Z-59 (2013)  
 REVISED  
 SITE PLAN

PROJECT  
 VILLAGE GREEN AT  
 EAST COBB

# Z-59

**ZONING COMMENTS:**

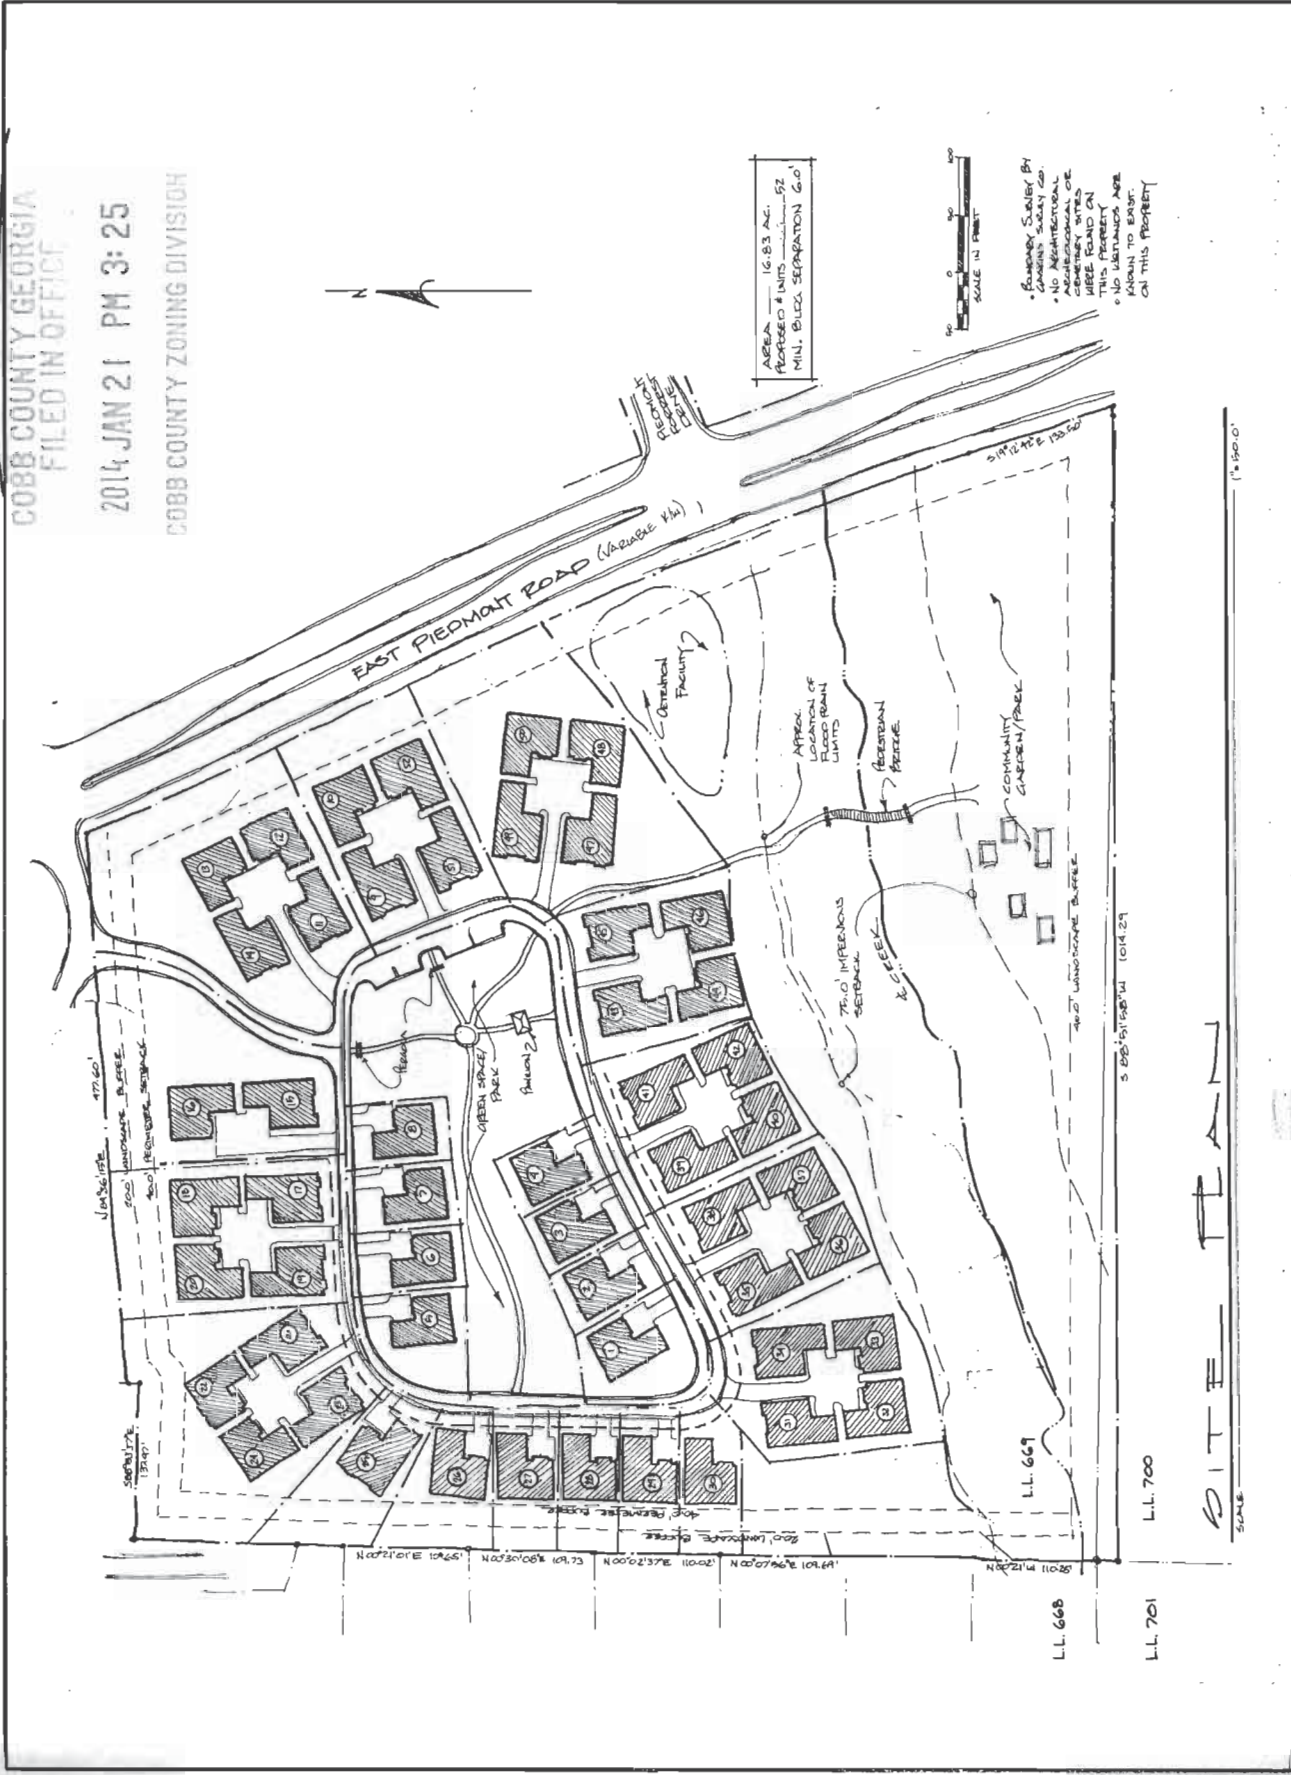
- Provide comprehensive hydrology/stormwater controls to include development of out parcels.
- Submit all proposed site improvements to Plan Review.
- Any **spring activity** uncovered must be addressed by a qualified geotechnical engineer (PE).
- Structural fill \_\_\_\_\_ must be placed under the direction of a qualified registered Georgia geotechnical engineer (PE).
- Existing facility.
- Project must comply with the Water Quality requirements of the CWA-NPDES-NPS Permit and County Water Quality Ordinance.
- Water Quality/Quantity contributions of the existing lake/pond on site must be continued as baseline conditions into proposed project.
- Calculate and provide % impervious of project site.
- Revisit design; reduce pavement area to reduce runoff and pollution.

- No Stormwater controls shown \_\_\_\_\_
- Copy of survey is not current – Additional comments may be forthcoming when current site conditions are exposed.
- No site improvements showing on exhibit.

- B. It is Staff's opinion that the applicant's rezoning proposal will not have an adverse affect on the usability of adjacent or nearby property. Applicant's proposal would be consistent and compatible with the some of the densities and uses of other properties in this area. The character of the area is defined with single-family houses, including Autumn Lake which has a density of 3.014 units per acre. The applicant has revised the plan to move the driveway to a safer location and to pull the development farther away from the floodplain.

- E. It is Staff's opinion that there are existing and changing conditions affecting the use and development of the property which give supporting grounds for approving the applicant's rezoning proposal. The RSL zoning district allows for up to five units per acre, which may be reduced based on topography and other concerns. The density for this project is just slightly over the range anticipated by the future land use map. The proposed development of 3.08 units per acre is consistent with other developments in the area. Staff is also concerned that the proposed plan does not meet the 15 feet between buildings requirement of the RSL (Non-Supportive) section on the ordinance.

- Maximum of 52 units;
- Detached units;
- Revised site plan received by the Zoning Division on January 21, 2014, with the District Commissioner approving minor modifications;
- Fire Department comments and recommendations;
- Water and Sewer Division comments and recommendations;
- Stormwater Management Division comments and recommendations; and
- Department of Transportation comments and recommendations.
